BEFORE THE ATOMIC SAFETY AND LICENSING APPEAL BOARD

Docket No. 50-382

WATERFORD UNIT 3 BASE MAT
JOHN S. MA
STRUCTURAL AND GEOTECHNICAL ENGINEERING BRANCH
DIVISION OF ENGINEERING, NRR, NRC
DECEMBER 10, 1984

Figure 1. Deflected shape of the Mat due to construction sequences

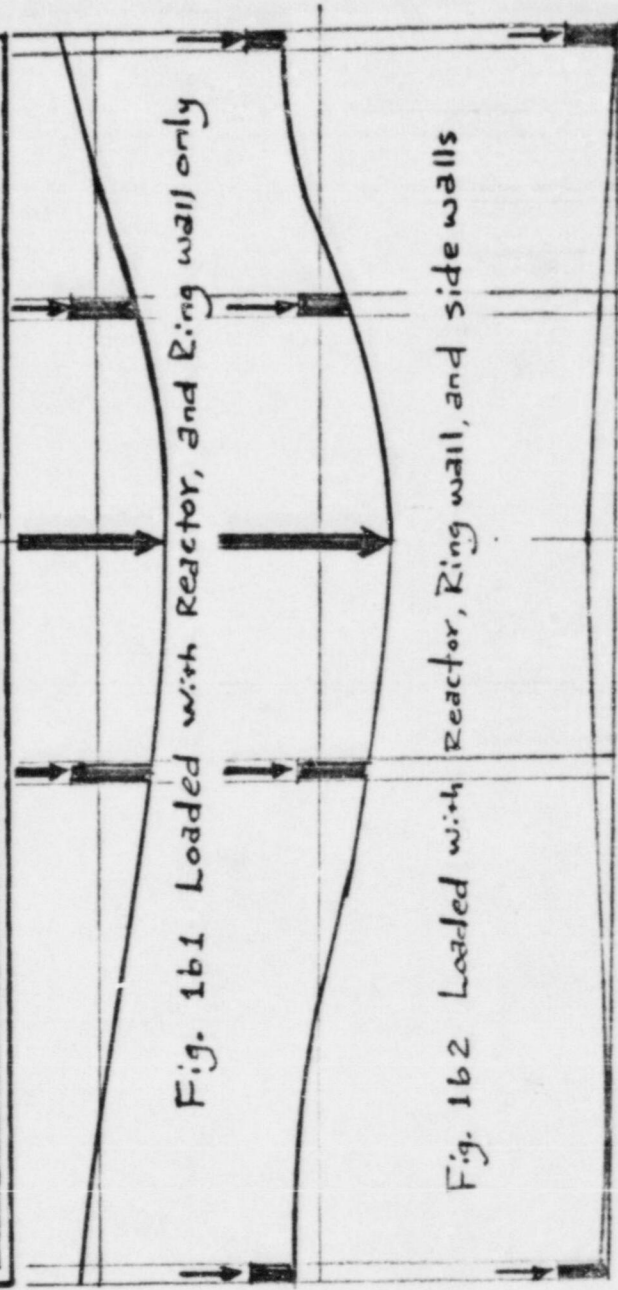
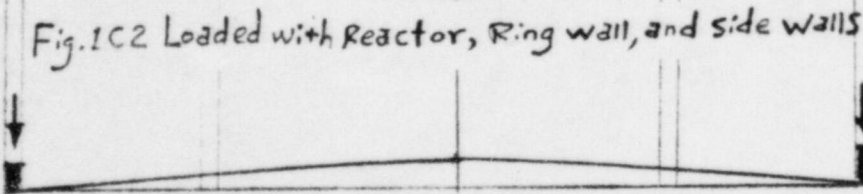
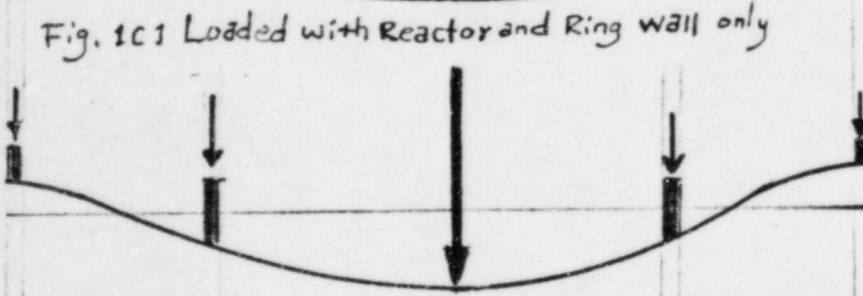
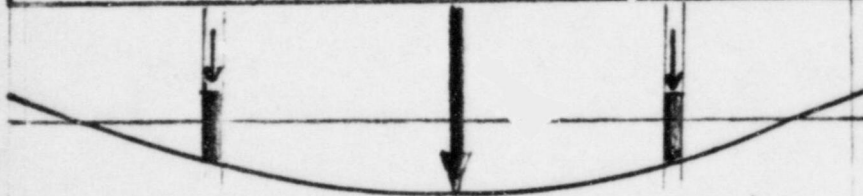
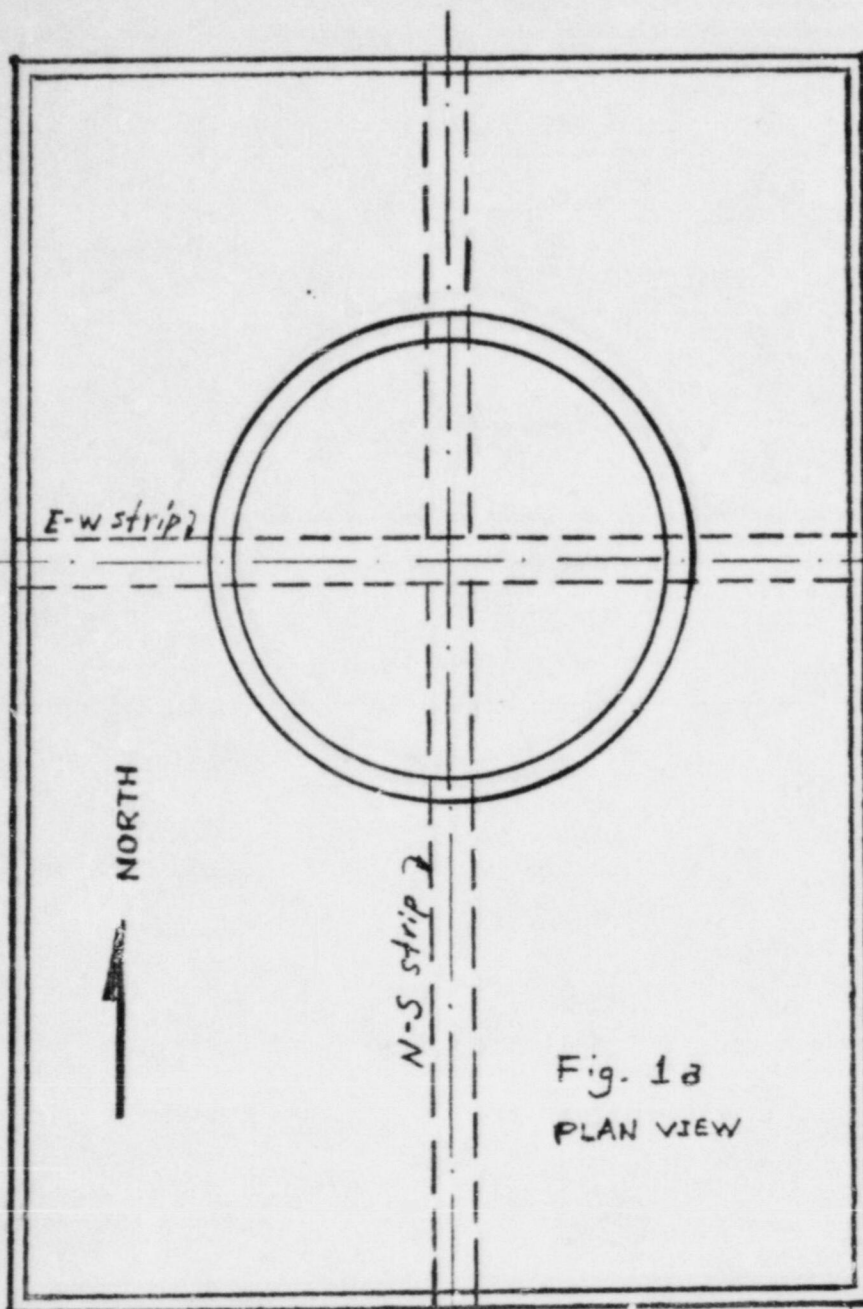
Figure 1a is a plan view of the mat supported by soils (soils are not shown). The mat is loaded with the weight of, and is restrained by, the side walls, ring wall, and structures within the ring wall including the reactor. A north-south (N-S) strip and an east-west (E-W) strip of the mat across the center of the reactor is shown in Figure 1a for later illustration purposes.

Assume that the ring wall and its internal structures including the reactor are first built on the mat. One can then visualize that the center portion of the mat will deflect downward and the edges upward with respect to the original assumed flat position. The deflected shape of the two perpendicular strips from Figure 1a is shown in Figures 1b1 and 1c1. These strips will deflect greatest among their parallel strips.

As the weight of the side walls is placed, the edges of the mat deflect downward and bend the outer portion of the strips into a convex shape, as shown in Figures 1b2 and 1c2. These deflected shapes suggest that

If the construction sequence is to build the side walls first, the mat will deflect into an inverted dish type with soils pushing upward. The deflected shape of the strips in Figure 1a will take the shape, as shown in Figures 1b1' and 1c1'. These two perpendicular strips will deflect more than any parallel strips. The amount of deflection of parallel strips decreases gradually in proportion to the distance to these strips, until alongside the side walls it approaches zero. This construction sequence requires rebars to be placed at the top of the mat in both N-S and E-W directions, with more rebars in the middle than at the edges. This type of deflected shape may produce tension cracks on

The BNL analysis result, as mentioned in the previous section, was a shock to me. It not only contradicted my intuition on the deflected shape of the mat, but also contradicted the analysis result presented by both EBASCO and HEA. In order to produce tension on the top surface of the mat under the reactor, it would require that portion of the mat to bend into an inverted dish type from an assumed initial flat position. Theoretically, it may be possible to produce such a shape with much heavier loads than the reactor acting outside of the ring wall with a particular arrangement for the mat stiffness and soil stiffness. However, with the heavy weight of the reactor acting downward and less heavy weight outside the ring wall, the deflected shape of the mat under

the reactor should be a dish type, as shown in Figures 1b2 and 1c2. EBASCO's computer analysis indicates compression at the top, as shown in Figures 2 and 3. The computer plot of the dish type deflection under dead loads was presented in Appendix E of HEA Report No. 2. I must conclude that the BNL analysis result is incorrect.

Fig. 3 MOMENT CURVE - SECT A-A (N-S BENDING)

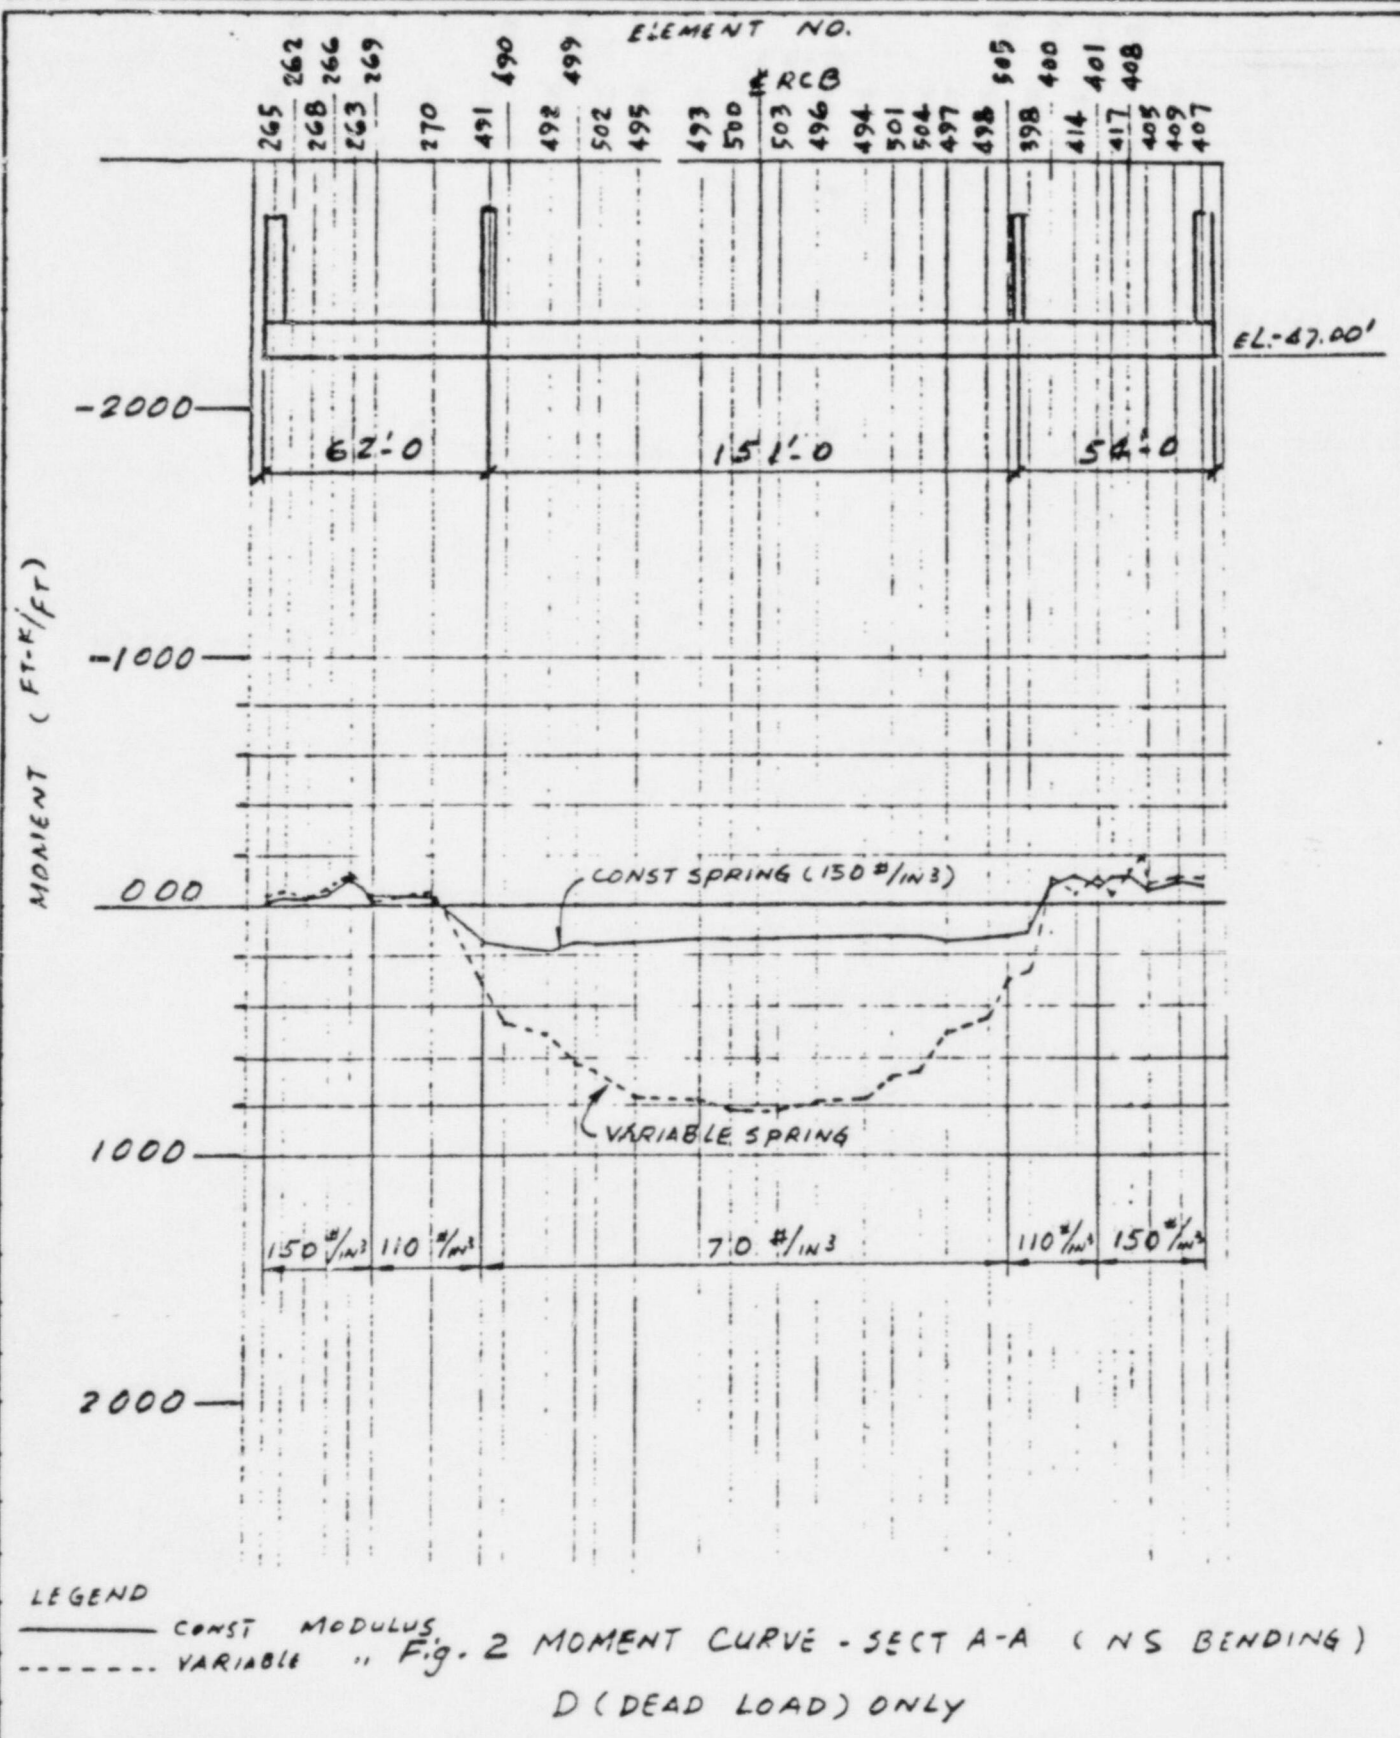
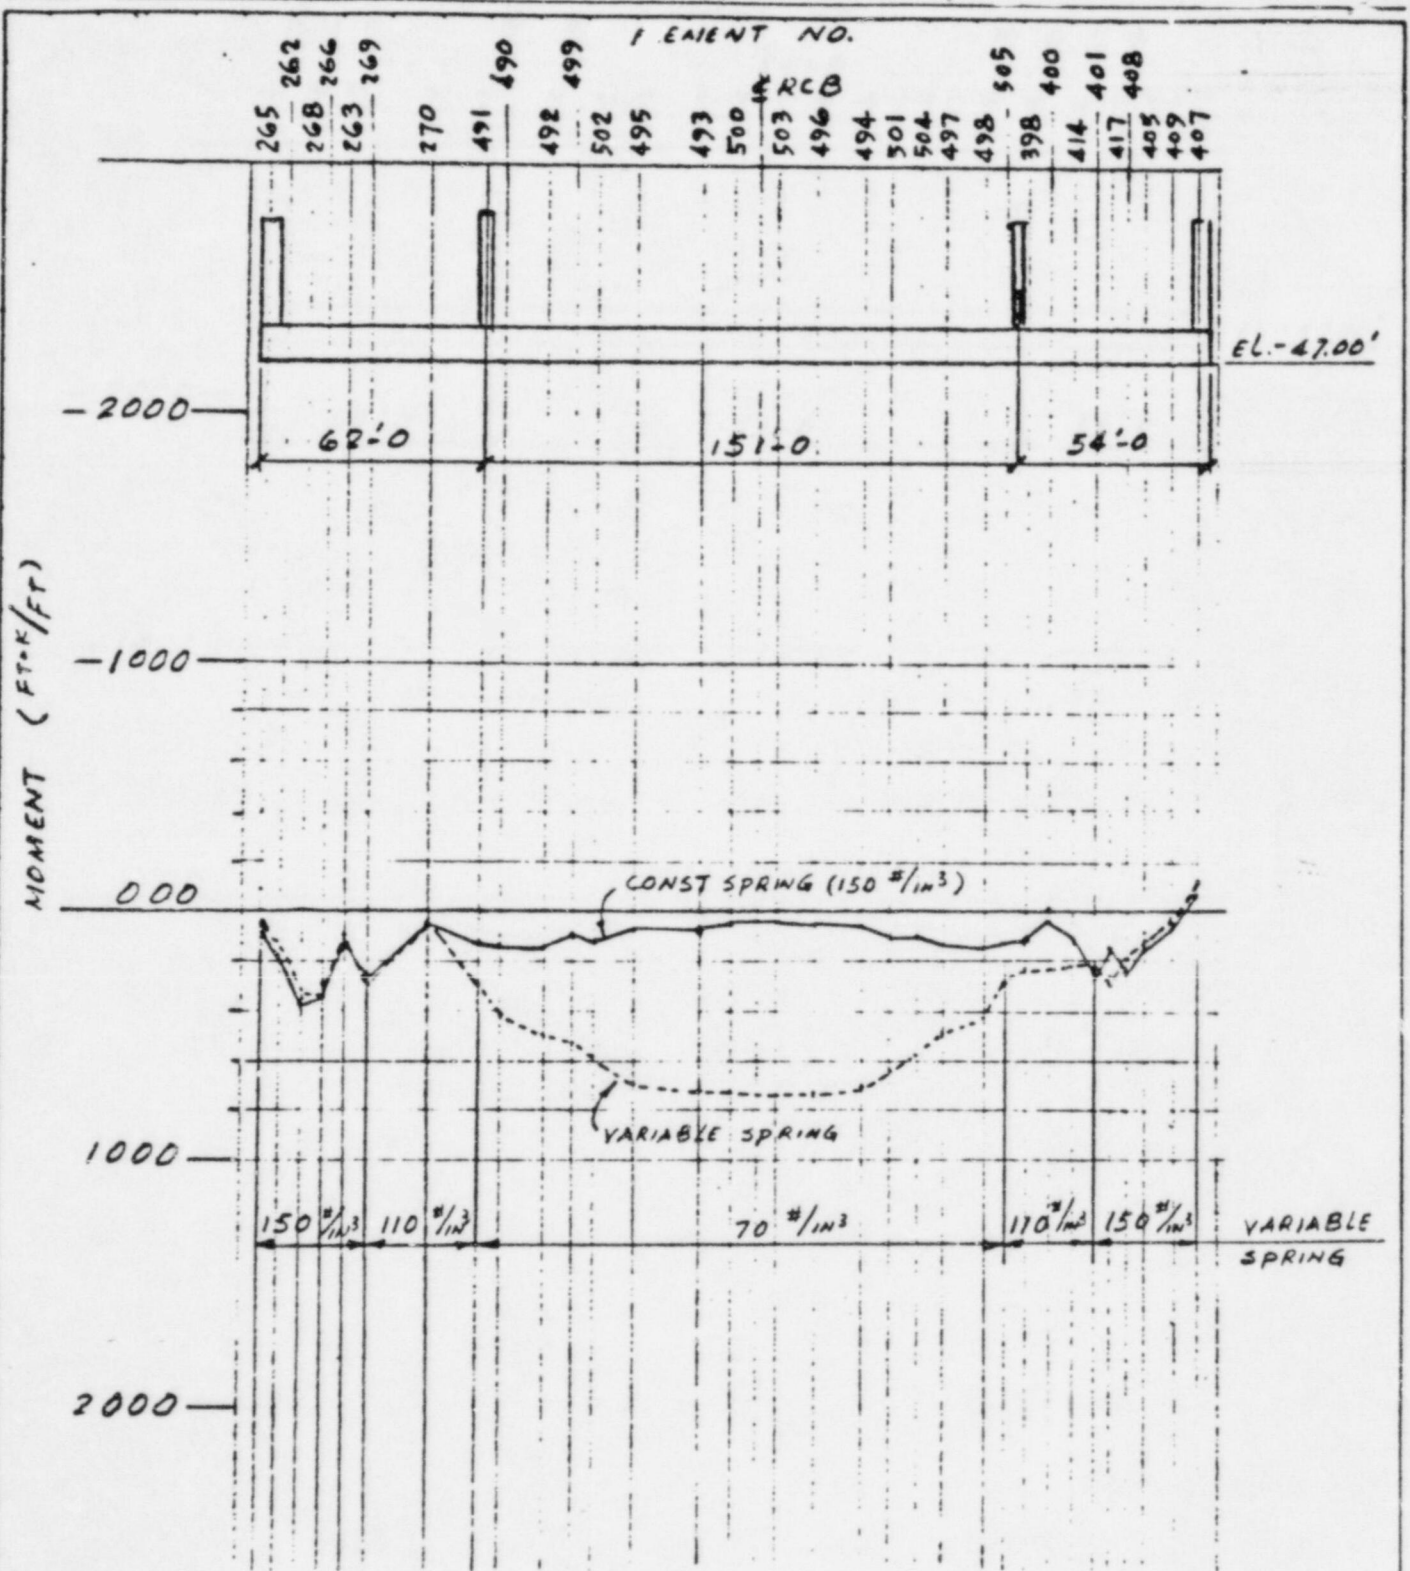
When the backfill soil level reaches about 6 feet above the top surface of the mat, additional backfill soils produce positive bending near the edges of the mat. This phenomenon can be seen by comparing the N-S bending (moment) distribution along an E-W strip across the center of the reactor, as shown in Figures 2 and 3. The main difference between the two figures is that no backfill soil was assumed in calculating the bending moment in Figures 2, while a full backfill soil was assumed in Figure 3. The negative bending moments, although small in Figure 2 have been reversed into positive bending moments in Figure 3.

EBASCO's computer results on the N-S bending across an E-W strip through the center of the reactor are plotted in Figure 2 with no backfill soils and Figure 3 with full backfill soils. Figure 2 shows a maximum positive bending moment of about 200 ft-k per foot width, and 800 ft-k/ft within the ring wall for a constant soil modulus and variable soil modulus, respectively, and a maximum negative bending moment of about 100 ft-k/ft and 200 ft-k/ft between the ring wall and side walls for a constant soil modulus and variable soil modulus, respectively. Figure 3 shows about the same magnitudes of positive bending moments within the ring wall, but also shows positive bending moments between the ring wall and side walls with a maximum of about 400 ft-k/ft. The reversal of this bending moment was mainly due to the difference between no backfill soils and full backfill soils assumed in the computer analysis. According to the actual construction sequence, the N-S bending moments between the ring wall and the side walls should vary along the zero line with a small variation for the assumed soil conditions.

Figure 2 illustrates changes in the magnitude of positive bending moments as a result of a change in soils stiffness alone. A change in soils stiffness from 150 pounds per cubic inch to 70 pounds per cubic inch within the ring wall resulted in a positive bending moment increase from about 200 ft-k/ft to 800 ft-k/ft. Since there is no analysis performed incorporating the actual soil condition, the maximum is not known for the stress level that the mat actually experienced during

In order to push the neutral axis down to 18 inches above the bottom face of the mat as stated in the BNL addendum, it requires a magnitude of negative bending moment of 2093 ft-k/ft to act on the cross section. This magnitude is about 20 times the magnitude of a negative bending moment generated from the mat with full dead loads and no backfill soils at all with an assumed soil modulus of 150 pound per cubic inch, as shown in Fig. 2 of this report.

Fig. 5 MATHEMATICAL MODEL FOR SEISMIC ANALYSIS
(HORIZONTAL EXCITATIONS)

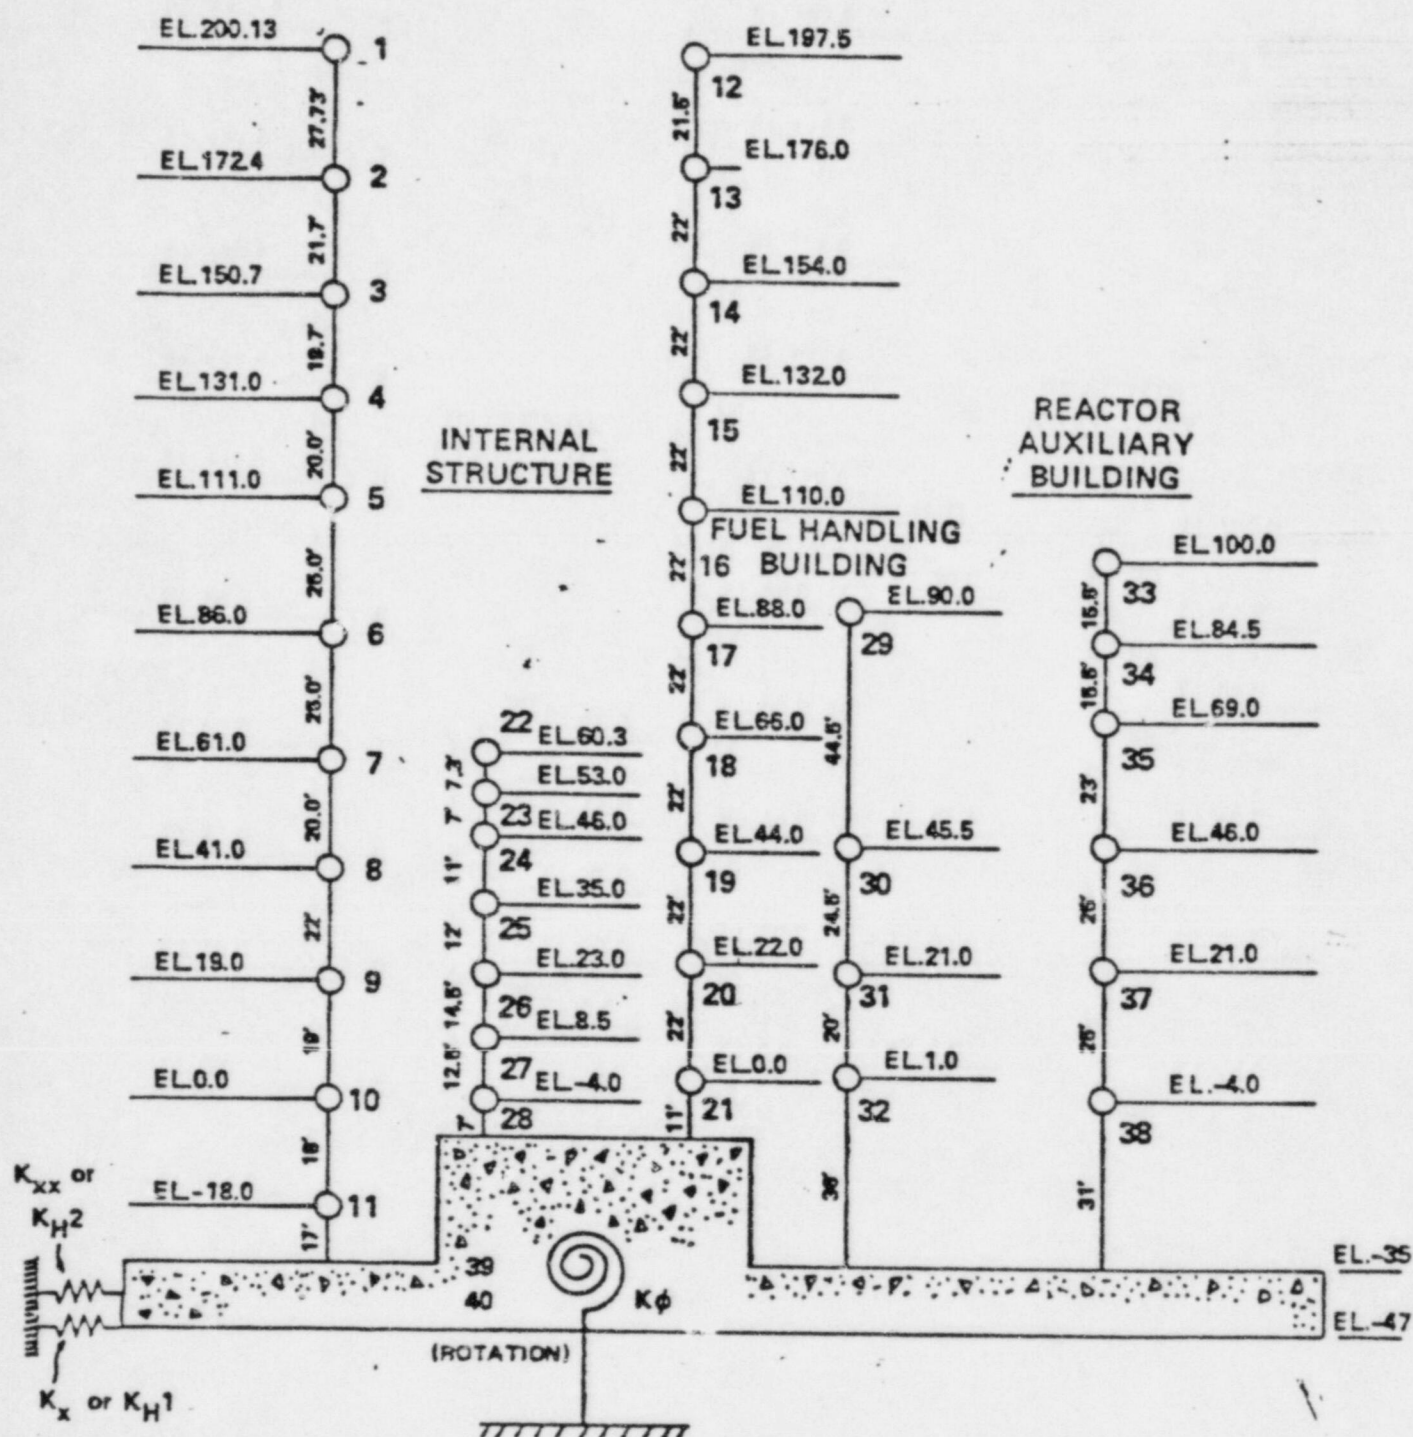
The response (displacement, rotation, strain, and stress) of seismic Category I structures, safety class equipment and piping, which are supported by the mat, was calculated by assuming the mat being one monolithic piece, as shown in Figure 5. The fundamental assumption in this mathematical model is that the mat will move horizontally or vertically and rotate about an axis in one monolithic piece during earthquakes. This assumption is valid if a small amount of shallow cracks are present in the mat, as envisioned in the HEA reports. The extensive cracking in both length and depth, as indicated by NDT, has raised a question on the validity of this assumption and a need for further examination.
